TO: James R. Jordan, Pinnacle Development Solutions
FROM: Jeff Hee, PH Consulting
SUBJECT: Park Heights Short Plat SUB25-00184
DATE: 4/7/2026

The following responds to comments from Finn Hill Neighborhood Alliance, specifically those raised by Tomas E. Hansen, PE. Written comments are listed below followed by our responses.

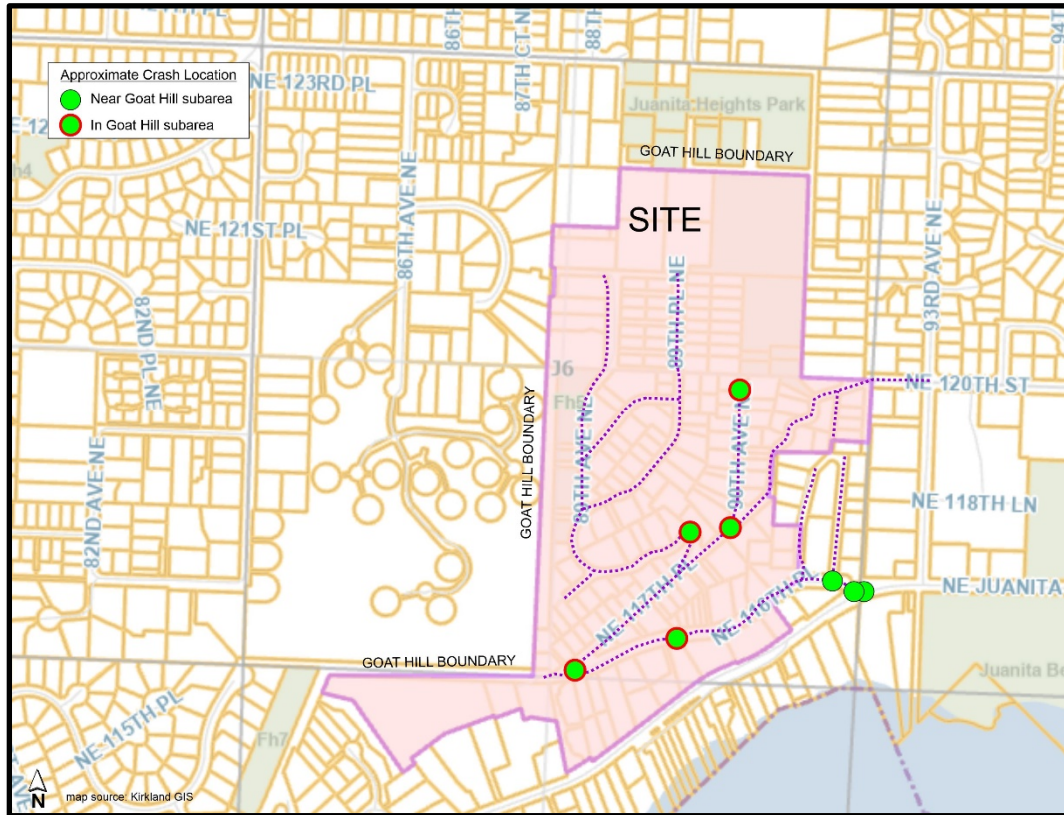
Comment 2. Sight Distance at Intersections. Seen during my field inspection, it appears that there are 4 public road intersection that probably do not meet City's existing sight distance requirements based on my experience and judgement. I looked through the available document record on-line and did not find any analysis or assessment of intersection sight distance at the marked four intersections (See attached map). The added traffic from the proposed short plat will impact the operation of these intersections if the sight distance does not meet standards. It is my recommendation that the short plat applicant be required to perform an analysis of the available sight distance at each of the four intersections for all directions of traffic, and if the deficient, be required to make improvements so that the sight distance at each intersection meets City code. If the sight distance at any or all of the intersections is found inadequate and improvements to meet code are not made, then approval of the short plat should be denied due to inadequate road conditions.

There were only 2 collisions reported at curved sections on Goat Hill in the past 5 years, in 2021 (at NE 117th Pl & 90th Ave NE) and in 2023 (on 118th Pl NE north of NE 117th Pl). None of the reported crashes in the Goat Hill area resulted in an injury or involved teen drivers, pedestrians, or cyclists. A map of the collision locations is below.

Response 2. Engineering drawings will be provided to show that the Applicant will meet their sight distance requirements at the development property and at their individual lots.

It has been recognized in the past that the existing roadways offer sharp turns with limited sightlines. An additional review of preexisting sightlines was not pursued. Guide/Warning signs can be discussed with Kirkland staff.

A 5-year crash history 2021-2025 showed 5 total crashes on local roadways on "Goat Hill," plus 2 crashes at NE 116th PI and NE Junita Drive and 1 crash at NE 116th PI & 91st Ln NE. The following summarizes the crashes reported in the Goat Hill area:
